Product Change Notification (PCN)

PCN #: 7I-2024

Date: July 10th, 2024

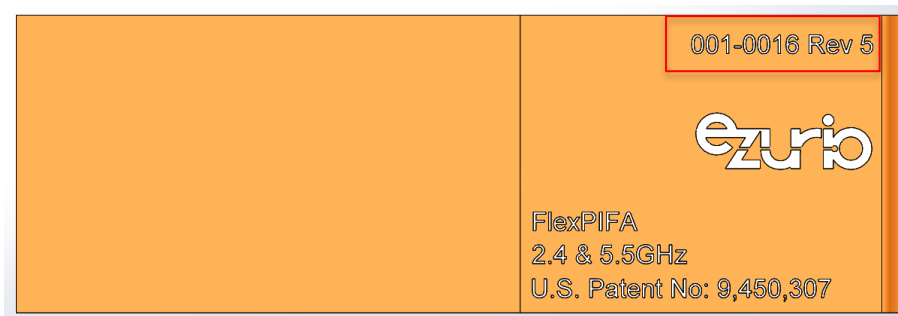
- The company name has been officially changed from Laird Connectivity to Ezurio. As a result, all product PCB Silkscreen labeling and packaging that previously displayed the Laird Connectivity logo will now feature the updated Ezurio logo. This change includes, but is not limited to:
 - Product labels
 - Product packaging

- Besides change in silkscreen to change the company logo from Laird Connectivity to Ezurio , there are no electrical RF implications for this change. There is no form, fit or functional changes.

5.2 Bag Label

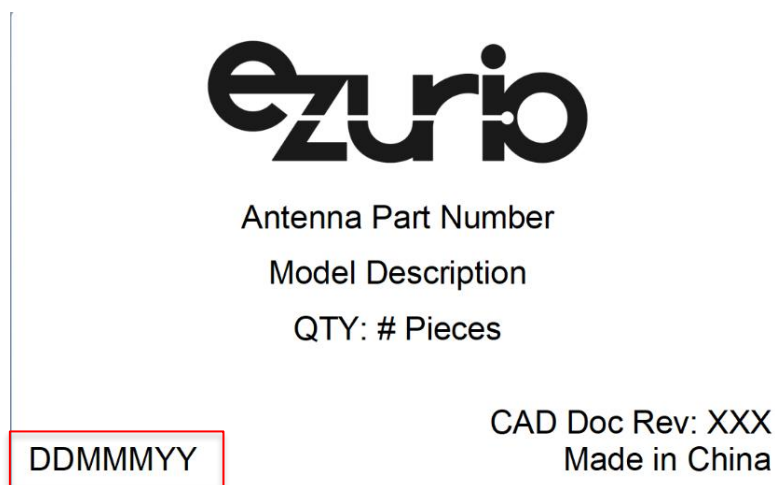
- Manufacturing date on the bag label will be June 2024 or later
